ASSESSMENT REPORT

Panel Reference	PPSSSH-126
DA Number	DA22/1126
LGA	Sutherland Shire
Proposed Development	Construction of 9 residential flat buildings comprising 686 dwellings (of which 351 are affordable housing) and 4 multi-level basement car parking areas for 886 cars; site preparation and formation works including tree removal, remediation, cutting and filing; landscaping works; civil engineering works including an access road and stormwater drainage and on-site detention facilities.
Street Address	113 Willarong Road, Caringbah
Applicant/Owner	Tier Architects P/L
Date of DA lodgement	14 December 2022
Total number of Submissions	• Total: 70
Number of Unique Objections	• Unique: 70
Recommendation	Refusal
Regional Development Criteria (Schedule 7 of the SEPP (State and Regional Development) 2011)	Section 2.19 and Clause 2, Schedule 6 of the SEPP (Planning Systems) 2021 – Capital investment value more than \$30 million.

Report prepared by	Simon Ip – Associate Director, Gyde Consulting on behalf of the Department of Planning and Environment
Report date	19 July 2023

SYDNEY SOUTH PLANNING PANEL

Figure 20 Approved site layout plan for 101-109 Willarong Road to the north of the subject site. (Source: DKO Architecture / Sutherland Shire Council)

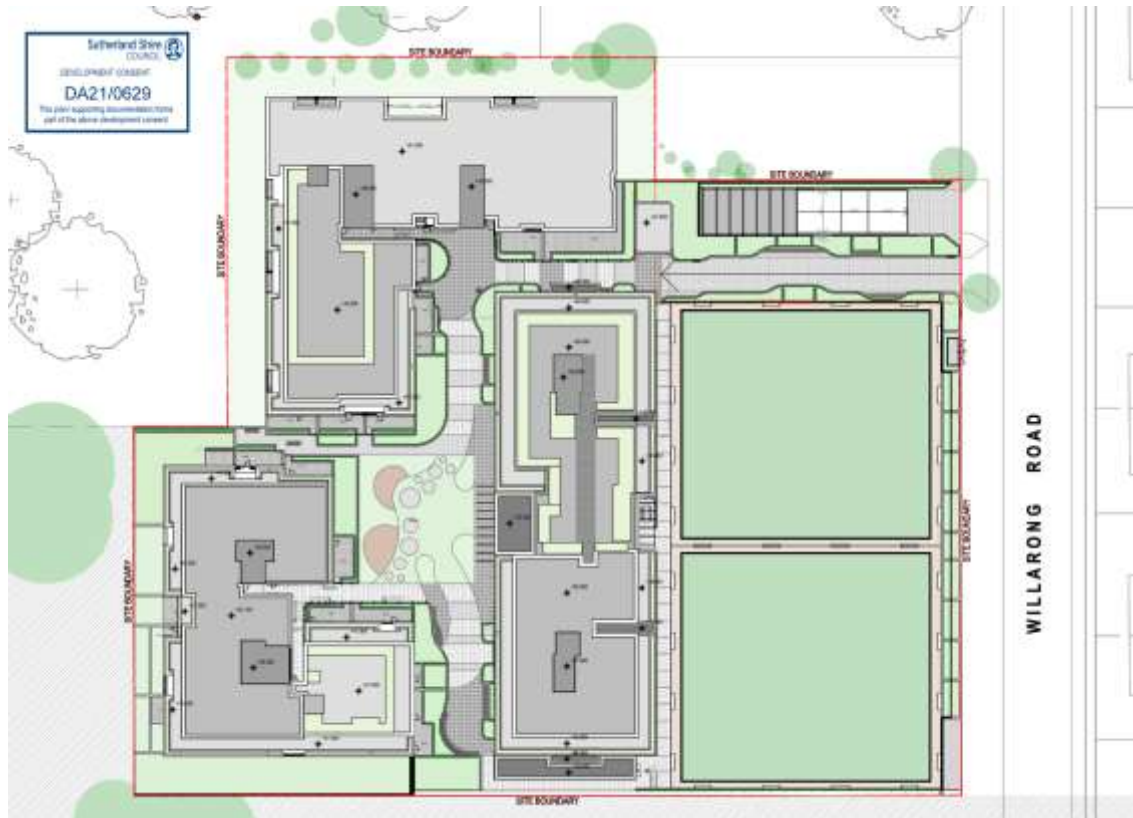
- Building F has a limited 4.5m wide setback to the northern shared boundary with the bowling club site. The approved mixed-use development on this adjoining site incorporates two bowling greens adjacent to the street frontage, with the 6- to 8-storey residential buildings located to the rear (setback approximately 45.7m from the front boundary) (see **Figure 20**). The height, scale and elongated form of Building F in conjunction with its limited northern setback are likely to result in visual intrusion when

viewed from the public domain and the adjoining and nearby properties. This arrangement also provides limited opportunities for through-site visual corridors and deep soil landscape screening to complement the character of the residential neighbourhood, where the recently completed residential flat buildings present as “pavilions” with smaller building footprints.

The proposal fails to demonstrate how it relates to the emerging streetscape rhythm and does not satisfy the assessment principles for side and rear setbacks under section 7.3.1, Chapter 7 of the DCP. The proposal fails to demonstrate that the side setback is sufficient to improve the streetscape as required by clause 6.17(c) of the LEP.

Figure 23 Significance of existing trees affected by the proposal. (Source: Sutherland Shire Council, based on drawing prepared by Tier Architects)

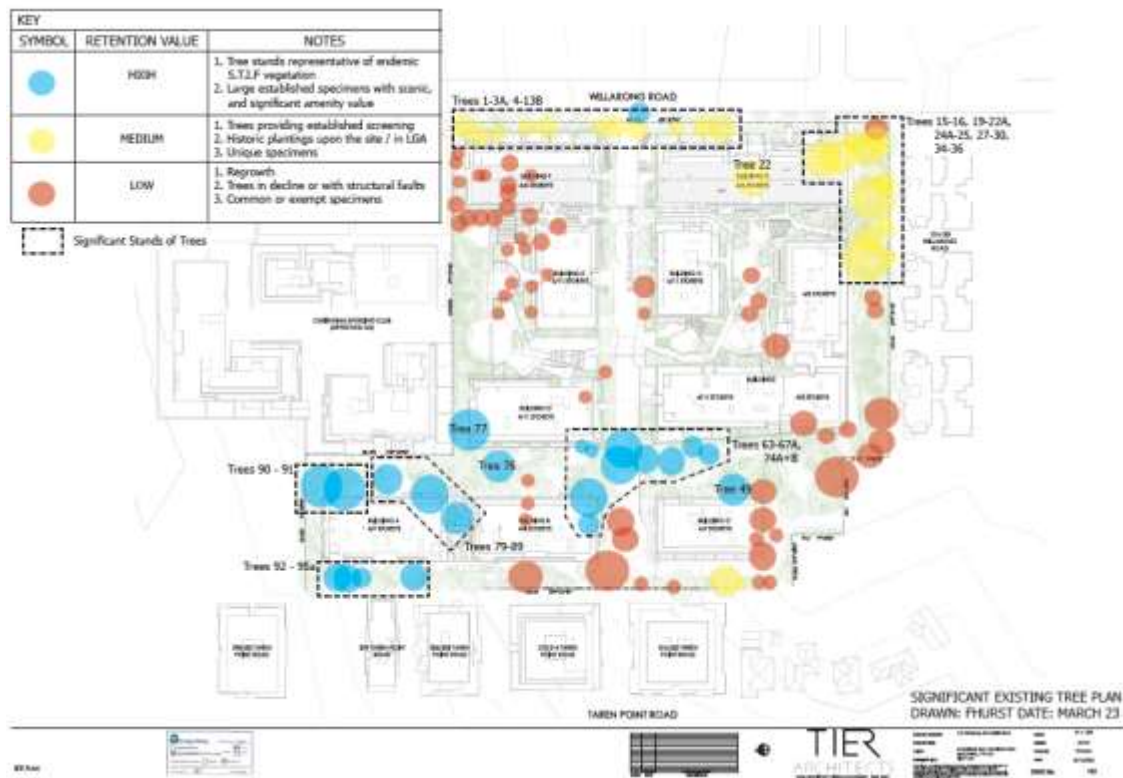
- The site is mapped as containing the Coastal Enriched Sandstone Dry Forest vegetation community by the former Office of Environment and Heritage (currently Environment and Heritage Group, Department of Planning and Environment) in 2016. Upon review of the Arborist Report and a site visit, Council identifies that the endemic trees which remain on the site are more typical of the critically endangered Sydney Turpentine Ironbark Forest (STIF) community. Despite the environmental significance of the trees and vegetation on the site, the proposal seeks to remove 77 trees, out of the 100 assessed in the Arborist Report, which are protected by chapter 39 of the DCP.
- Council has mapped the existing trees on the site and their significance, noting many trees of high and medium significance will be impacted by the proposal.

- Despite the environmental significance of the site, the architectural design has dictated which trees are possible for retention rather than respecting and developing around the high valued trees and stands of vegetation.

- The proposal seeks to remove over 25 trees of the STIF community and retain only 5 of them. The proposal intends to remove two significant stands of STIF trees being trees 63-67A, 74A & 74B and 77-89.

- The proposal intends to remove two large Ficus Hilli of a height that will provide immediate relief between the subject and adjoining site at No.105 Willarong Road.
